DESIGN OVERSIGHT	DESIGN BY T. PHAM	CHECKED Y. REN	PREPARED FOR THE SACRAMENTO COUNTY DEPARTMENT OF TRANSPORTATION	JASON HICKEY PROJECT ENGINEER	BRIDGE NO. 24C0606	LAGUNA CREEK BRIDGE (REPLACE)	
SIGN OFF DATE	DETAILS BY G. BOYKO	CHECKED T. PHAM			POST MILES	INDEX TO PLAN	
DESIGN DETAIL SHEET (ENGLISH) (REV.7/16/10)	QUANTITIES BY G. GUARDADO	CHECKED N. FELDE	ORIGINAL SCALE IN INCHES FOR REDUCED PLANS	UNIT: X PROJECT NUMBER & PHASE: X	DISREGARD PRINTS BEARING EARLIER REVISION DATES	REVISION DATES (PRELIMINARY STAGE ONLY)	SHEET 2 OF 23
				FILE => \$REQUEST	CONTRACT NO.: X PROJECT ID:

95% SUBMITTAL

SECTION D-D
1/2" = 1'-0"

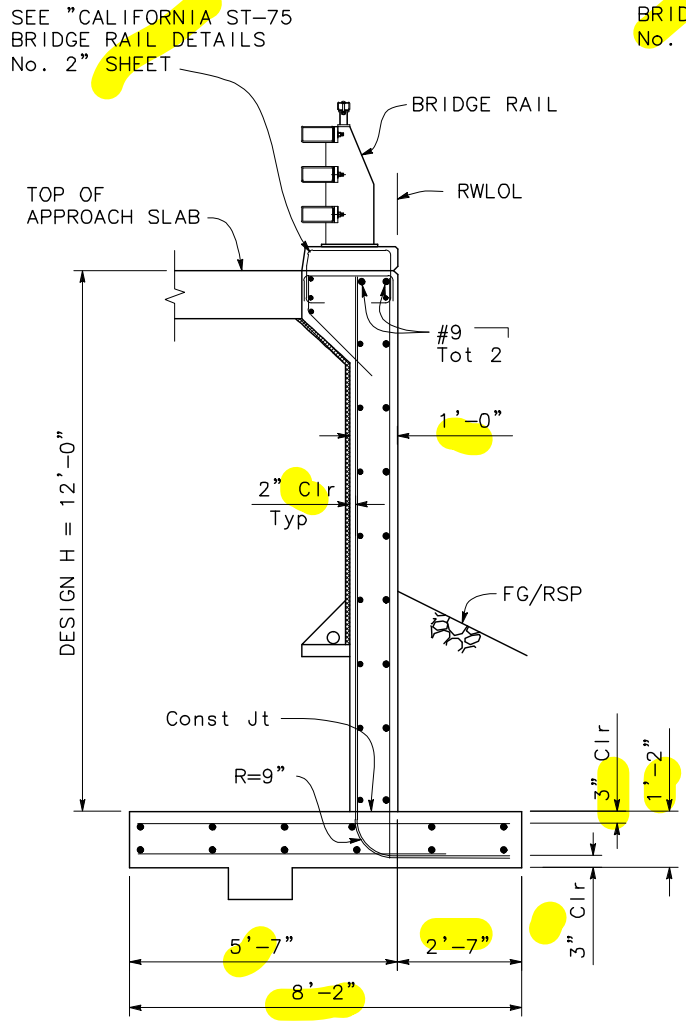
~~For details and reinforcement not shown, see RSP B11-77~~

SECTION E-E
1/2" = 1'-0"

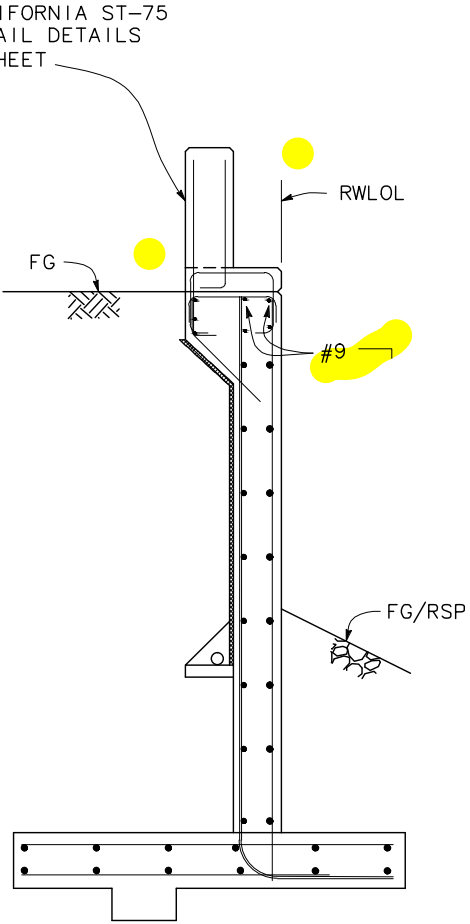
~~For details and reinforcement not shown, see RSP B3-3A and RSP B11-77~~

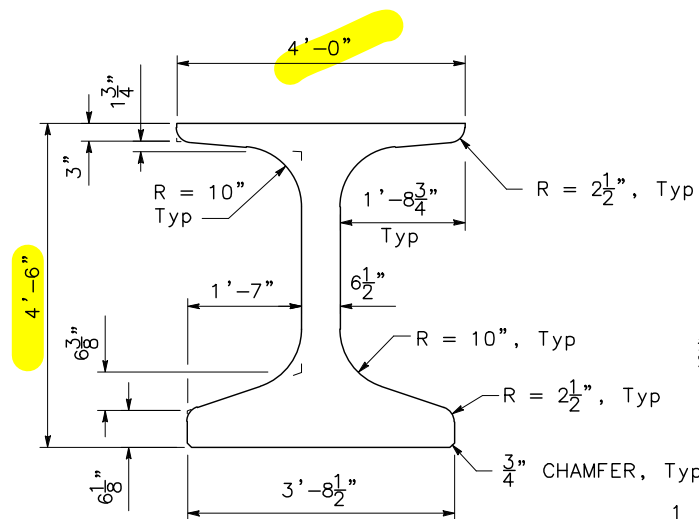
why PT needed? OK to keep

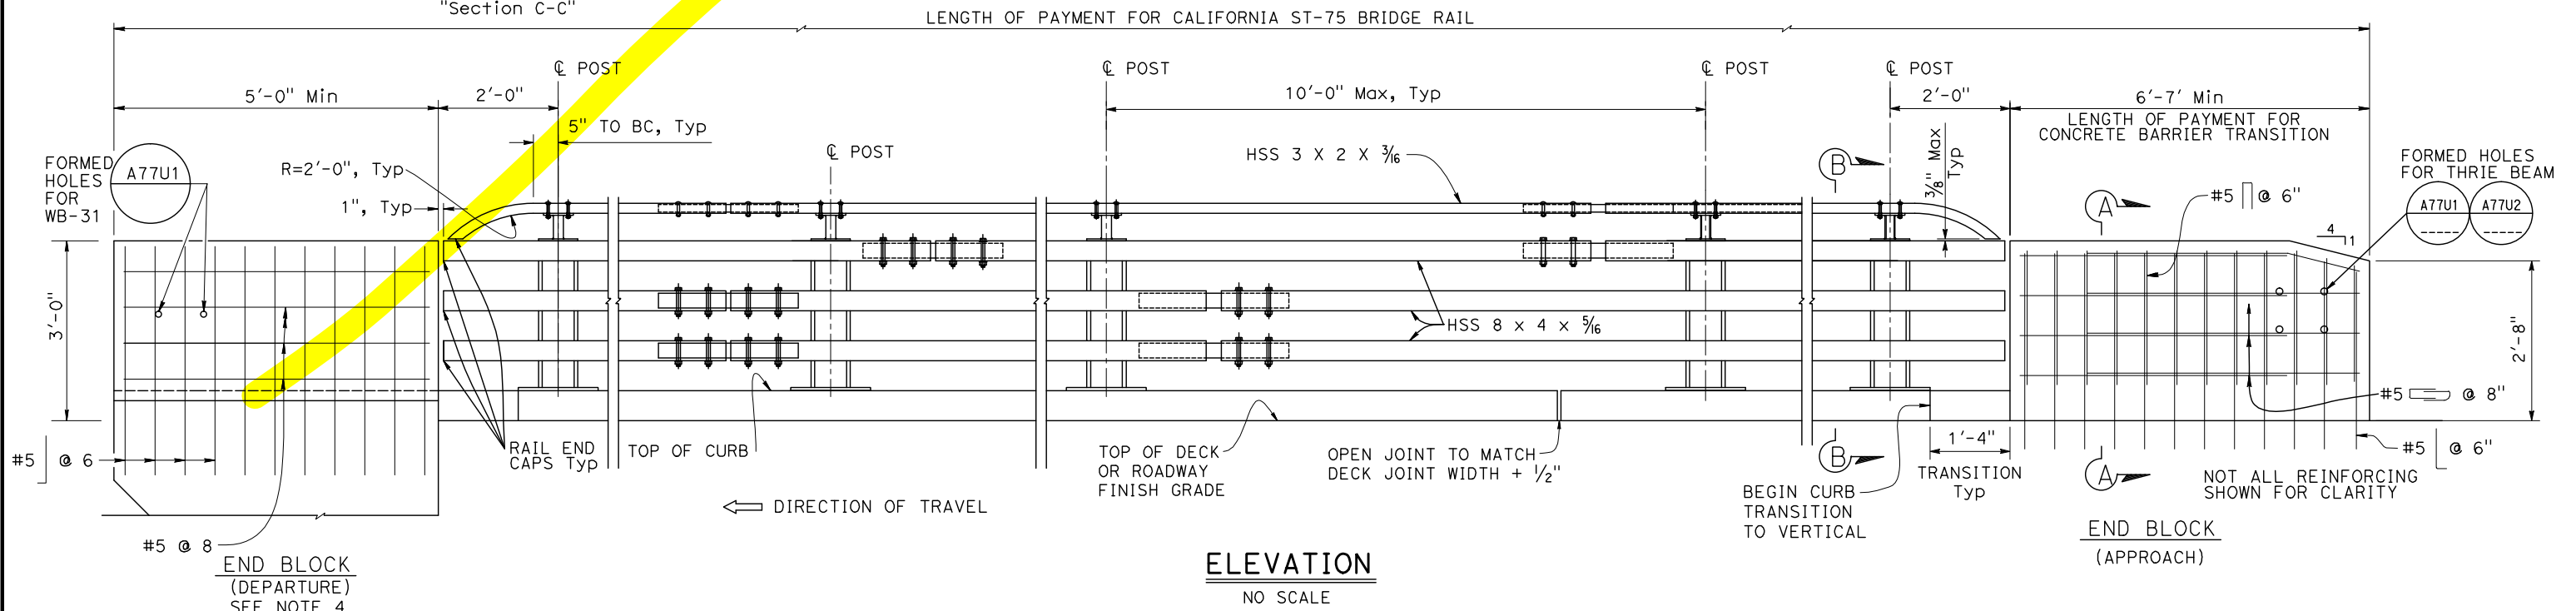
clean up
